**Information Request Response (Pursuant to Section 13.2 of the *Development Assessment Rules*)**

**Your Ref: MCUI/2023/991**

**345 Punchs Creek Road, Punchs Creek QLD 4357**

On behalf of Punchs Creek Renewable Energy Pty Ltd we refer to Toowoomba Regional Council's information request, dated 21 April 2023, and the further advice required items raised via email received on 23 November 2023, for the development application over the above site.

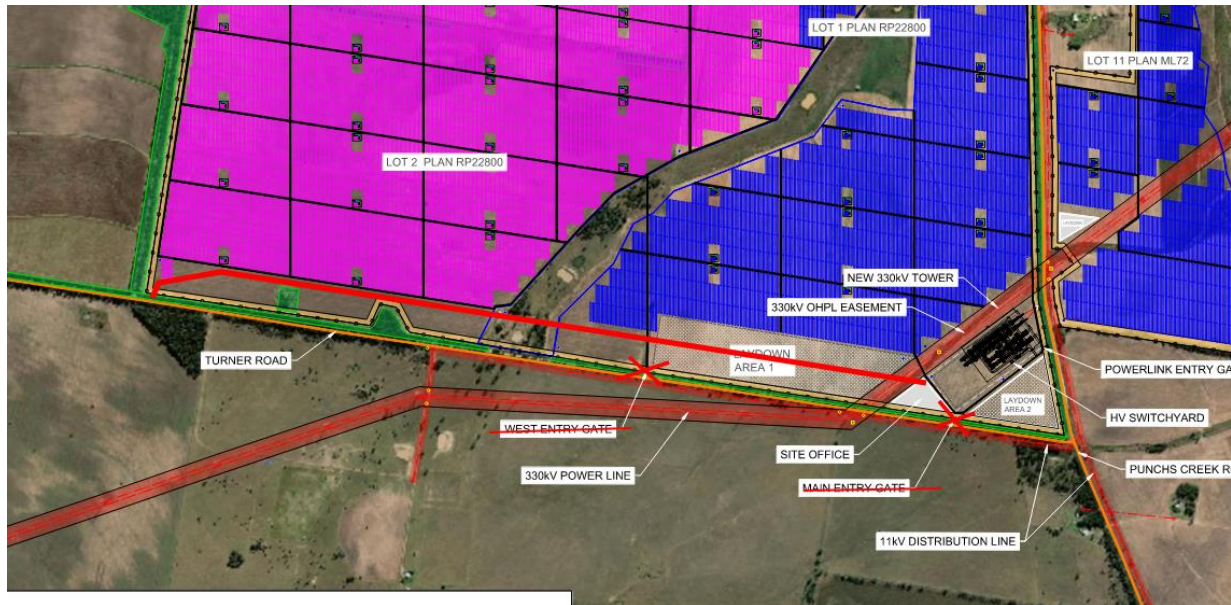
The proposed site access to Turner Road occurs in two locations at the west entry gate and main entry gate. The TIA assumes all vehicles will access the site from the west and this means construction traffic uses some 2.9km of Turner Road (gravel) and this road will be impacted by construction vehicles. If site access to Turner Road was confined to a single access driveway at the western end of the development site, then only some 500m of Turner Road (gravel) will be impacted by construction traffic. An internal access road could be provided within the development site.

Please consider the provision of a single development access to Turner Road at the western extremity of the development site (Please refer to proposed access in red line on the below image). All of Stage 1 and Stage 2 traffic would use this access, reduce the damage to the gravel section of Turner Road and reduce the extent of seal extension works required.

The Applicant has considered the suggestion of a single development access to Turner Road at the western extremity of the development site and is not in favour of this for the following reasons:

- As shown in the image above, the proposed access in red line would require the following impacts to:
  - a) MSES Regulated vegetation (category B), Regulated Vegetation Management Category B containing endangered regional ecosystem, possible Threatened Ecological Community (TEC) associated with RE 11.4.3, and TRPS Areas of Environmental Significance and Areas of Environmental Significance Buffer.

The proposed development has deliberately avoided any impacts to these mapped areas (magenta overlay on the image), including in the south-western corner of the development land, specifically to remove any potential impacts to the flora, fauna and habitat values over which the mapping intends to prevent.

- Additionally, the proposed access in red line (on the further advice required image further above) would require crossing over/through the Powerlink easement and under the 330kV powerlines. This would involve a negotiated access agreement with Powerlink which is likely to include vehicle restrictions and other possible conditions of use.

In summary, whilst it is assumed the suggested single access at the south-western corner of the project land intends to minimise or avoid potential road widening/upgrade requirements to this gravel section of Turner Road, on balance the Applicant believes the proposed West Entry Gate offers the most practical and least impact access point for the Development. It presents the least possible environmental and ecological impacts, circumvents negotiating an access agreement with Powerlink which may involve conditions that can't be met, and crucially avoids seeking to cross through land that is not involved in the Development Application and over which the Applicant has no rights to access.
